**LEGAL ADVERTISEMENT
HISTORIC PRESERVATION BOARD
CITY OF PORTLAND
Public comments are taken at all meetings.**

HISTORIC PRESERVATION BOARD

HISTORIC PRESERVATION BOARD AGENDA **January 21, 2015 5:00 p.m. - Room 209, Portland City Hall**

House Island - Proposed Energy Building
Preliminary for Historic Preservation Review
Conceptual Site Plan

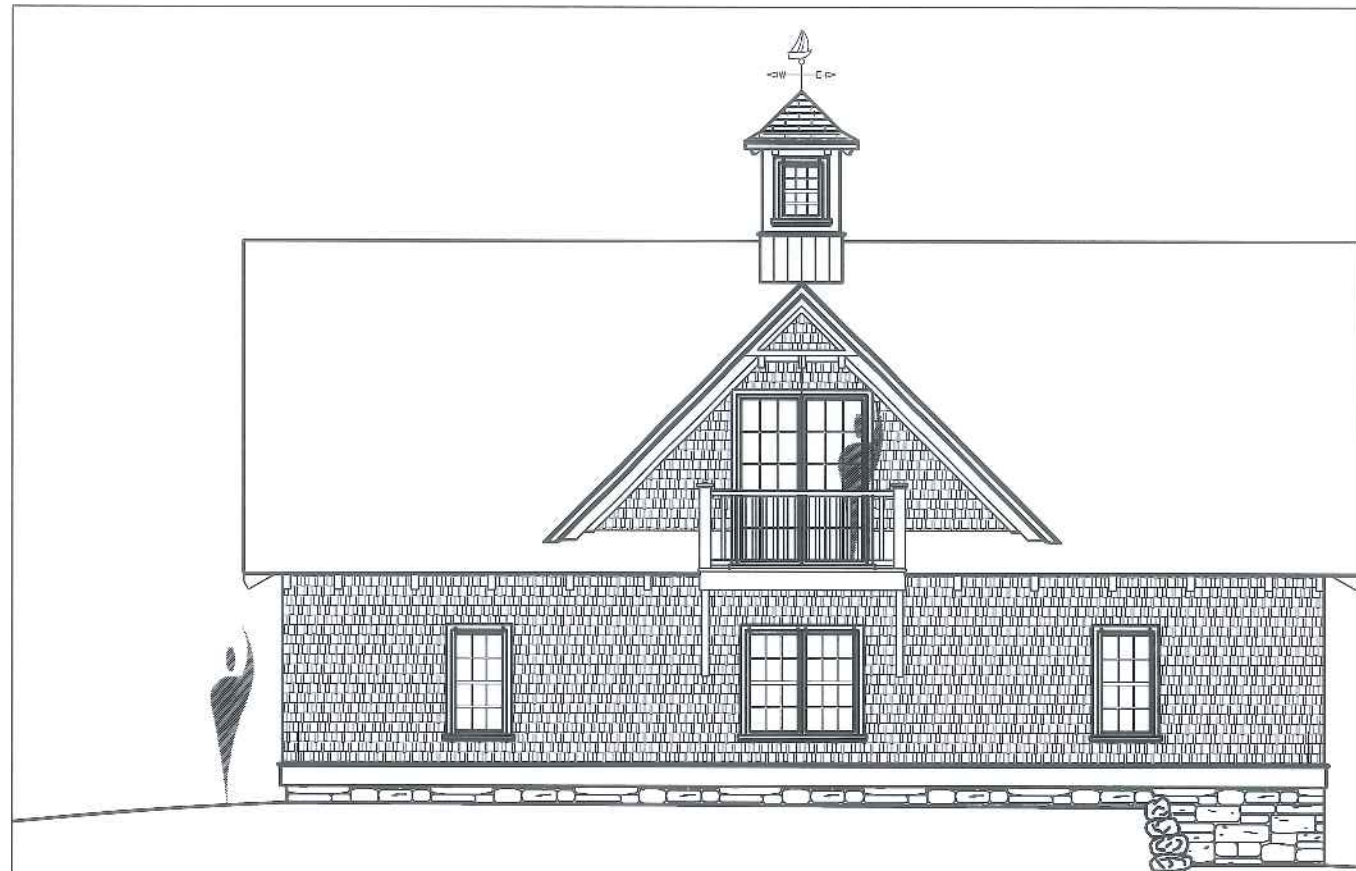
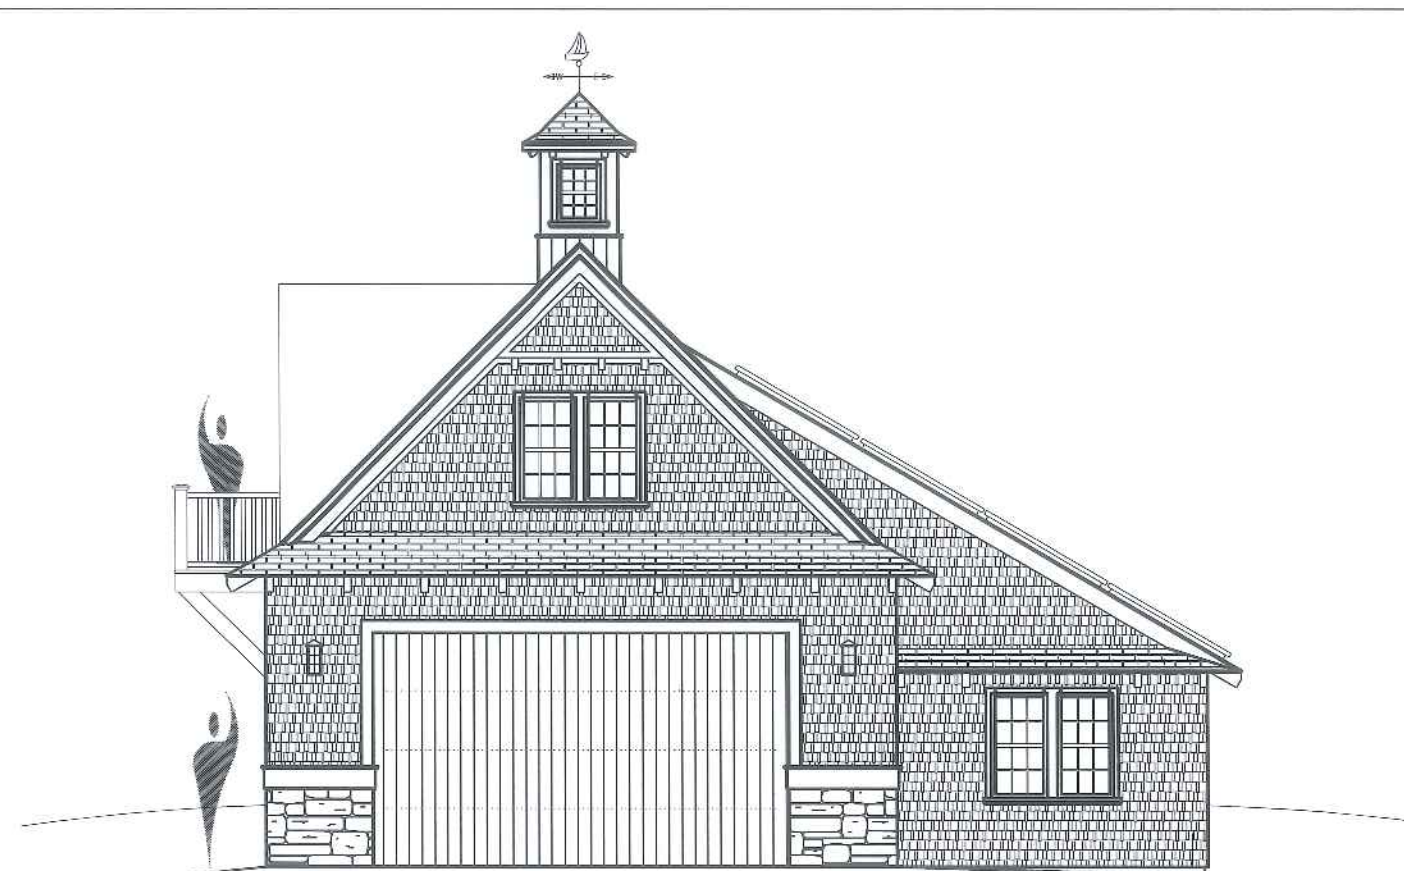
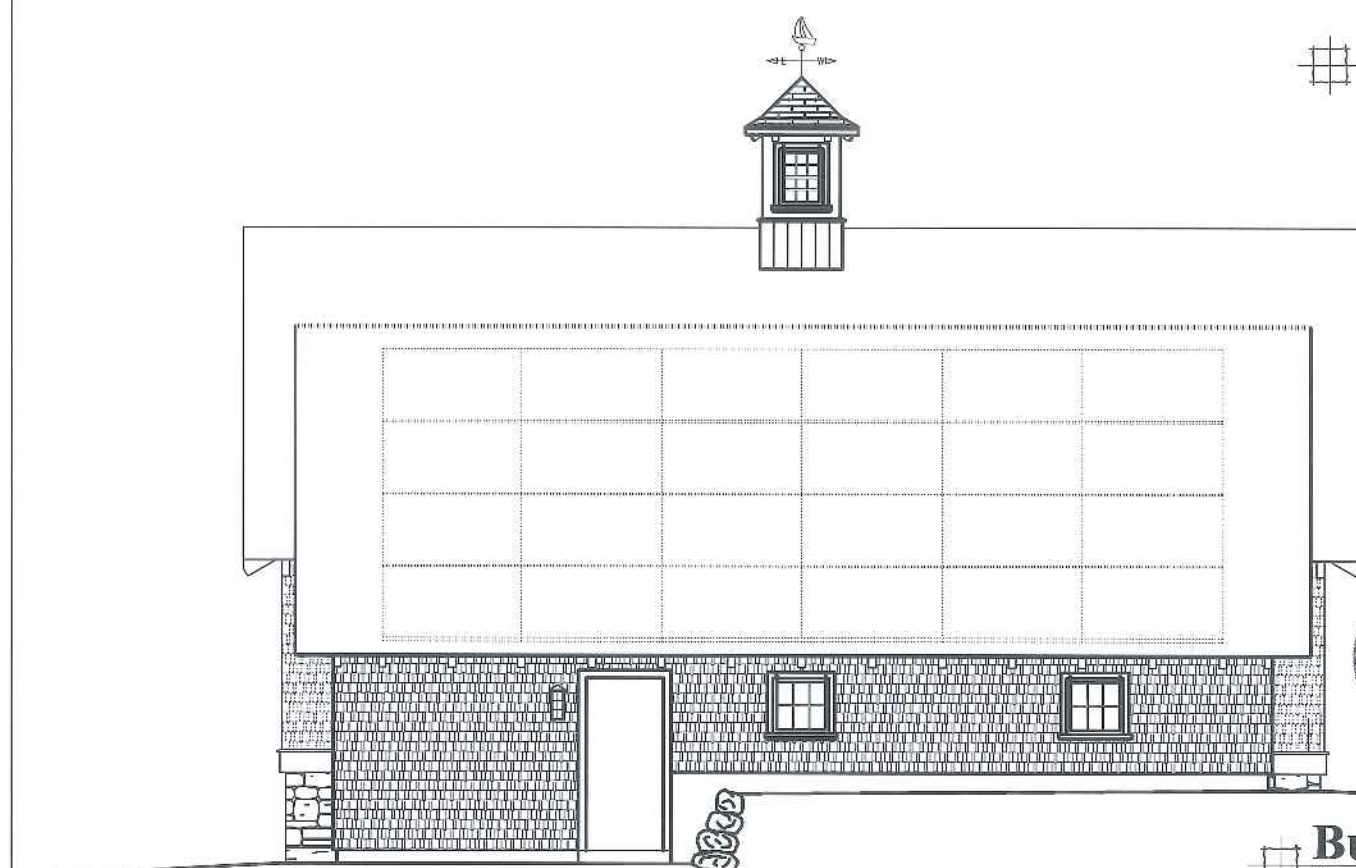
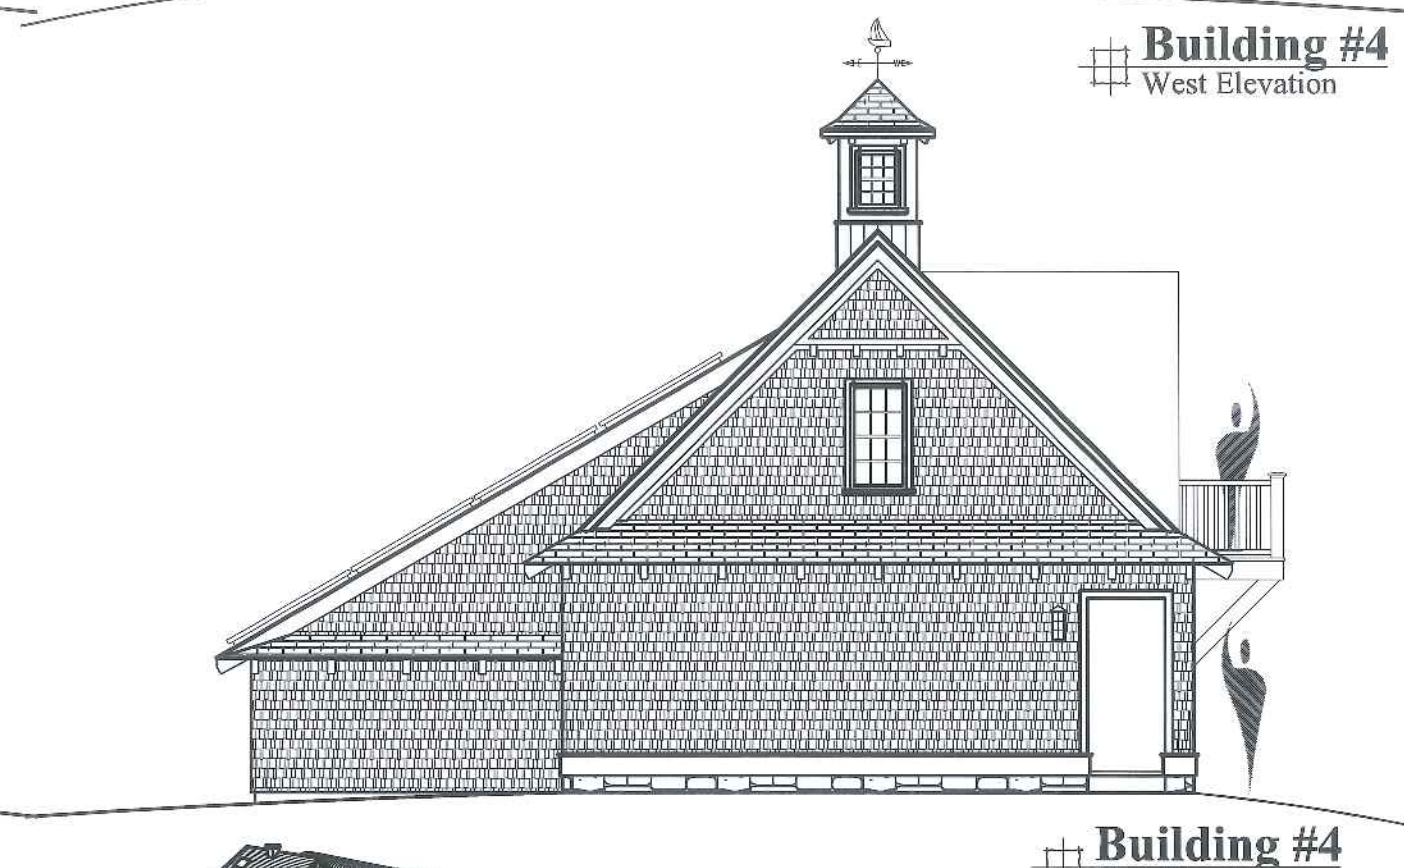
As a preliminary workshop, the Board's review should begin with general considerations, such as the scale, form and massing of the building; placement and orientation; overall architectural expression and material palette. These characteristics should be considered in the context of the existing pattern and character of development on the north end of House Island. Focus on specific architectural details should be addressed only after these threshold questions are considered.
